May 30, 2014

Dr. Stella Swanson
Chair, Joint Review Panel
Deep Geologic Repository Project

**Deep Geologic Repository Project for Low and Intermediate Level Waste –
Submission of Responses to Information Requests in Package #12b**

**OPG Responses to Information Requests in IR Package #12b from
Joint Review Panel**

IR#	EIS Guidelines Section	Information Request and Response
		 <p>Figure 4. Vertical Fault Base Case scenario results for 2011 safety assessment and with decommissioning wastes, showing the contribution of the specified decommissioning radionuclides.</p>

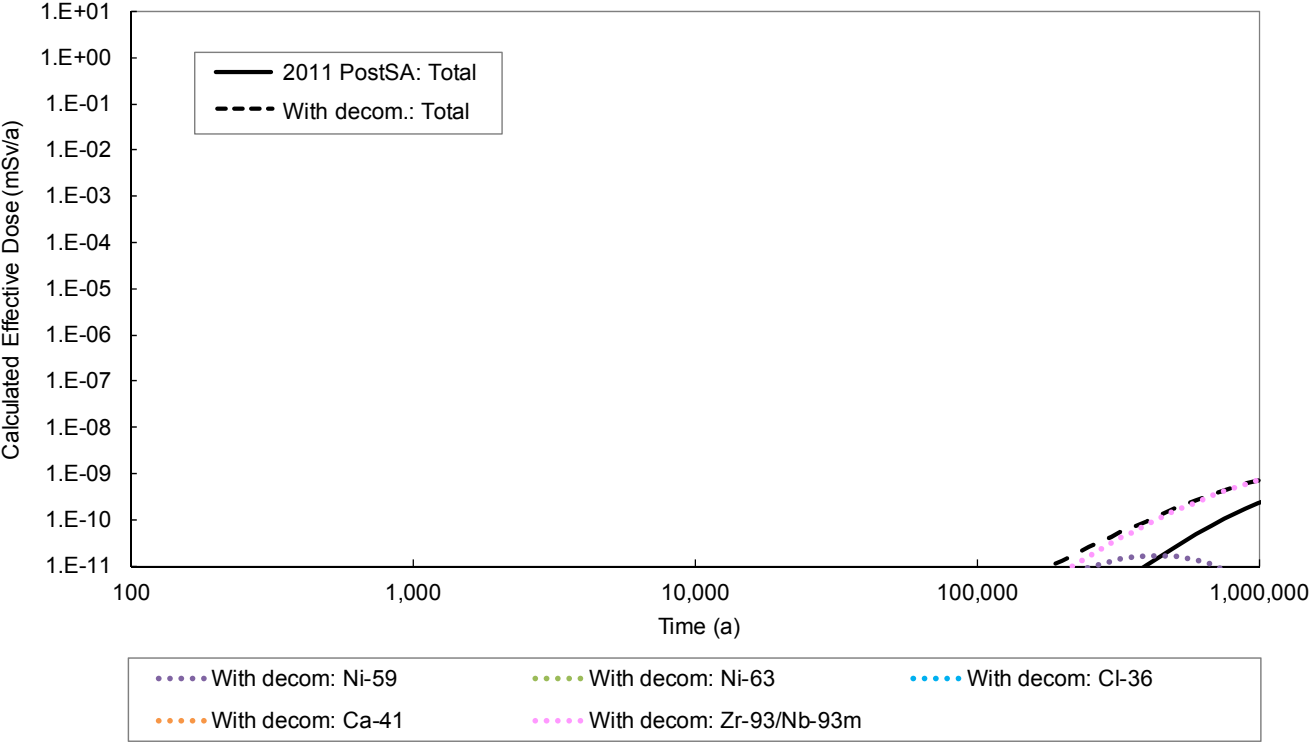
IR#	EIS Guidelines Section	Information Request and Response
EIS 12b-512	<ul style="list-style-type: none"> Section 14, Cumulative Effects 	<p>Information Request:</p> <p><i>Provide a more detailed evaluation of the contribution of the radionuclides “expected to be significantly higher in wastes from decommissioning than in operational and refurbishment wastes” to the maximum doses for each of the Disruptive Scenarios for an expanded repository than was provided in the response to information request EIS 12a-512.</i></p> <p>Context:</p> <p><i>In Section (b.2) - Postclosure Disruptive Scenarios - of the response to EIS 12a-512, OPG addresses the anticipated impact of decommissioning waste on the maximum dose rates to an adult for disruptive scenarios. It is stated that "The waste types from decommissioning are similar to wastes arising from operations and refurbishment, but different in amounts and key radionuclides..." and that "...the inventories of Ni-59, Ni-63, Fe-55, Co-60, Cl-36 and Ca-41 are expected to be significantly higher in wastes from decommissioning than in operational and refurbishment wastes." Some of the significantly more abundant radioisotopes have long half-lives (e.g., Ca-41 at 1×10^5 years).</i></p> <p><i>While the response notes that "... these radionuclides are not significant contributors to the dose impacts from the Disruptive Scenarios and so an increase in their inventory is not expected to increase maximum calculated doses," a fuller evaluation of their contribution to maximum doses for each of the Disruptive Scenarios for an expanded repository was not provided.</i></p> <p>OPG Response:</p> <p>In response to this Information Request, the following figures (i.e., Figure1 through Figure 4) show the potential contribution of the requested radionuclides Ni-59, Ni-63, Cl-36 and Ca-41 to the postclosure dose rate as a function of time for different Disruptive Scenarios. These figures also include the dominant radionuclide, if different than the requested radionuclides. The short half-lives of Fe-55 (2.7 a) and Co-60 (5.3 a) mean that these are not significant in postclosure safety despite the additional inventory.</p> <p>The postclosure safety assessment results shown in the figures indicate that, when including the estimated additional decommissioning inventory, the identified radionuclides contribute to the peak dose rate, but are not expected to dominate the maximum doses for each of the Disruptive Scenarios. The increases in the peak dose rates in these figures are primarily due to the increased amount of C-14, Nb-94 and Zr-93 from the wastes arising from decommissioning, as previously noted in the response to EIS-12a-512.</p>

IR#	EIS Guidelines Section	Information Request and Response
		<p>These results must be considered as illustrative because:</p> <ul style="list-style-type: none"> • The inclusion of wastes arising from decommissioning within the DGR would be subject to a future decision and a licensing process, and would require a detailed analysis. • The amount of wastes are based on conceptual plans for decommissioning methods, waste segregation and volume reduction . • The detailed characterization of the wastes arising from decommissioning will not be completed for 20-30 years until after the units have been shutdown; these results are based on an early estimate. • A detailed repository expansion design for wastes arising from decommissioning has not been completed. • The postclosure safety assessment results presented here were simply obtained by adding the estimated decommissioning inventory to the reference 2011 DGR postclosure inventory, rather than by a detailed model of the expanded repository.

Figure 2. Relative risk assessment for four disposal options according to pathways of harm for first 100 year period.

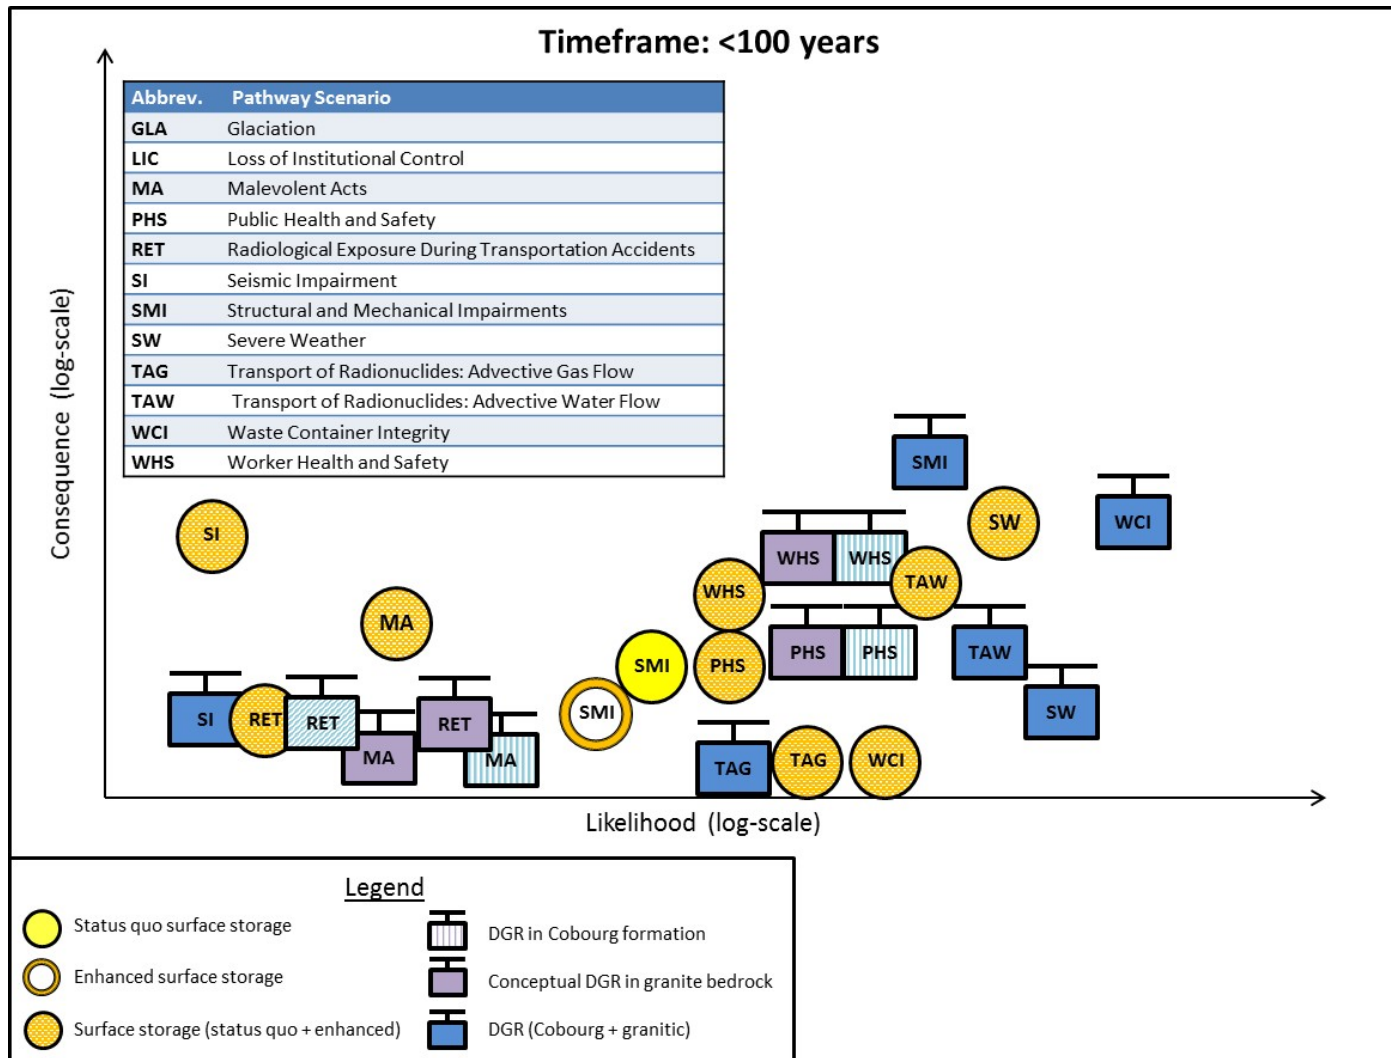
b) Provide a table and/or figure with accompanying explanatory narrative that summarizes the overall relative risks of the four identified options for the long- term management of low and intermediate level waste, over both timeframes (<100 years and >100 years). Include this summary in OPG’s separate submission to address the Panel’s follow-up comments on the comparison of risk perception among the four options.”

In response to part (b) of the request, we have provided additional figures which provide an overall perspective on the relative risks of the four disposal options, for both timeframes previously assessed. The following section includes an explanation of these figures. This document assumes that the reader is familiar with the previous IEG report (Reference 1). Since the time of this request, we have provided a separate report that addresses the risk perception component of part (b) of the request (Reference 2).

To provide an overall perspective on the array of risks posed by the four disposal options, we have provided two figures (Figures 2 and 3), one for each of the two timeframes. In viewing and interpreting these figures, the following concepts should be carefully considered:
